**City of Portland, Maine - Building or Use Permit Application**

RE: 8 Sunset Road, Peaks Island -90-D-1 & 2 – IR-2 Zone with Shoreland Overlay  
#06-1247

RENOVATIONS TO  
**DAY'S END**  
 8 SUNSET ROAD  
 PEAKS ISLAND, ME

**A2**

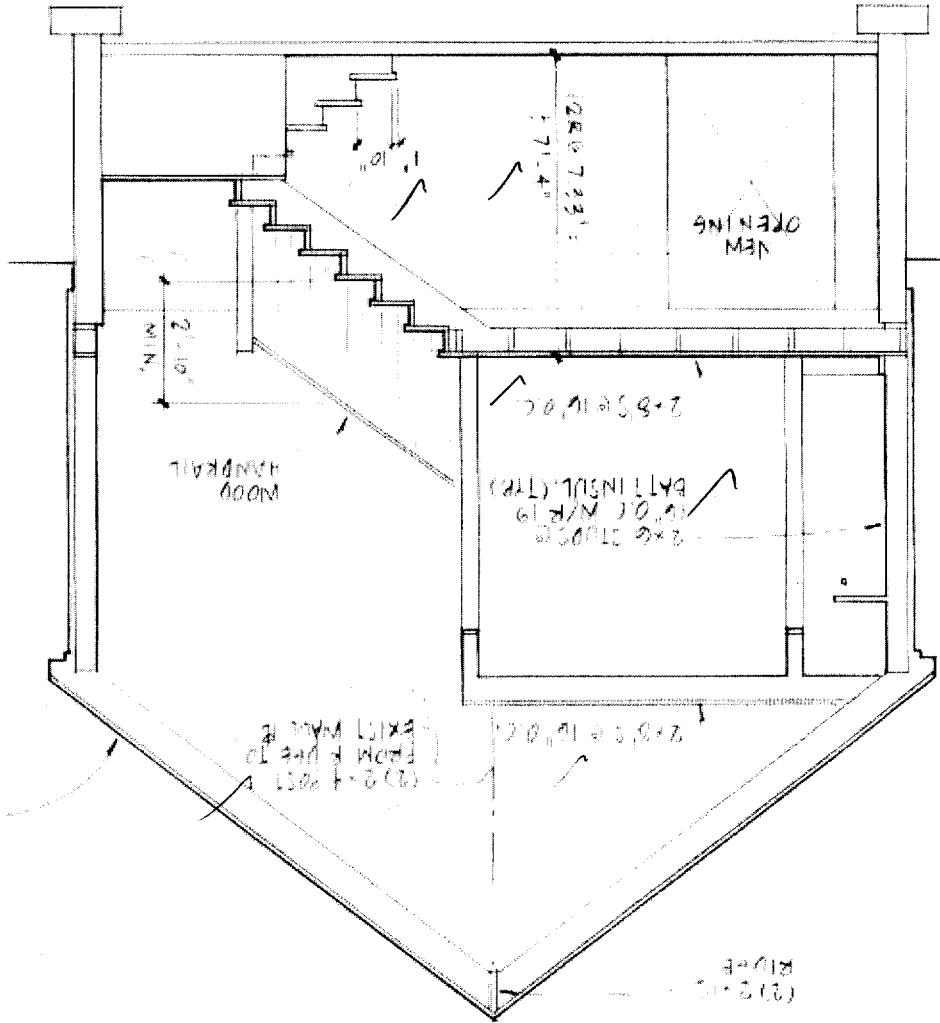
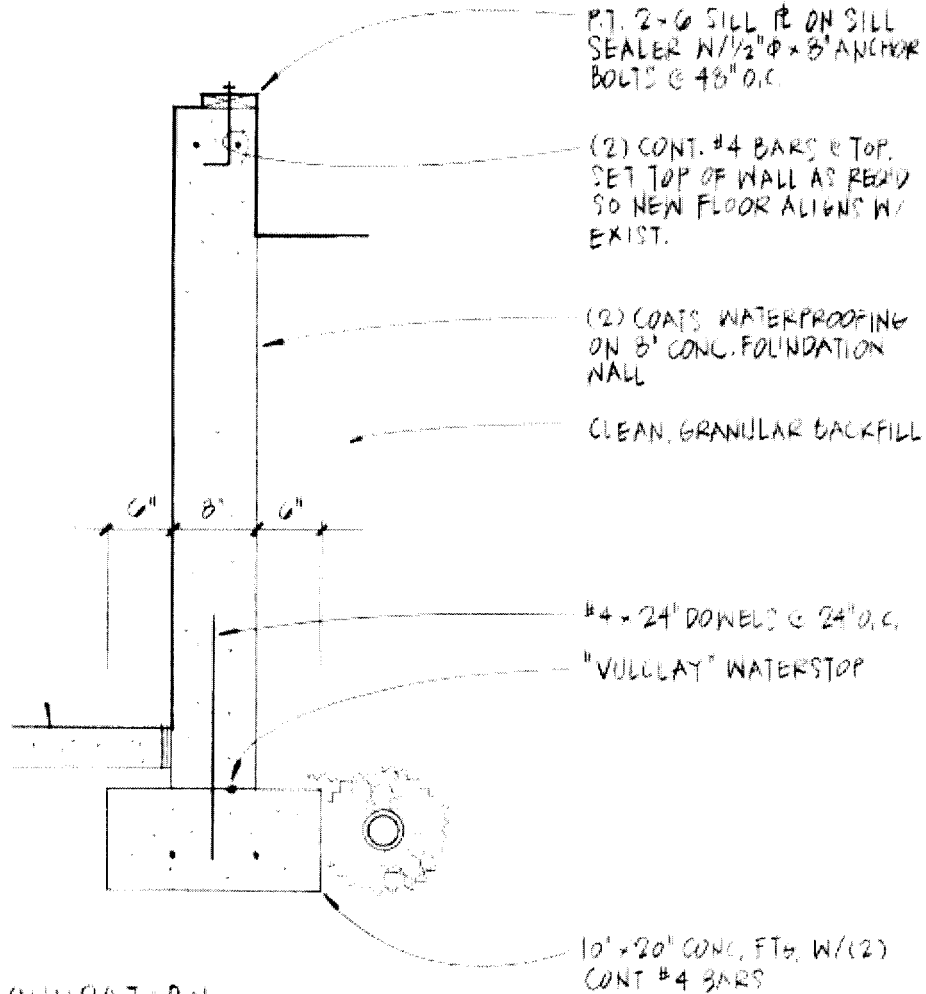
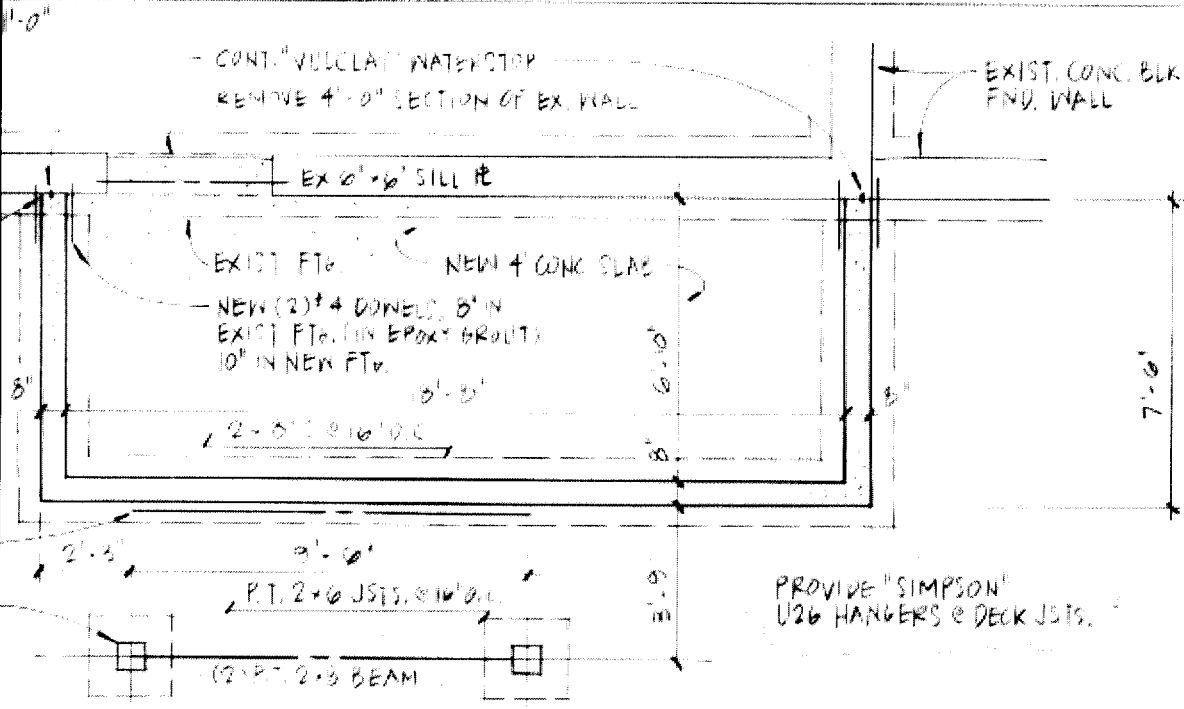
You can just label the elevation of the front elevation and the cross section that was submitted. They were pretty bare regarding info.

1. The windows within 2' of doors must be tempered.
2. Header schedule for windows and doors
3. Treads/headroom in stairs
4. Framing detail of exterior porch floor and roof
5. Insulation values
6. Fully labeled cross section of the addition

I will make a note regarding the windows to be tempered. All headers are to be (3) 2 x 10's. The treads to the basement will be 10 inches with a 1 inch nosing. There is no stair over the basement stair - there is no headroom issue. The 2 x 6 walls are to have R-19 batts, and the roof R-30 batts.
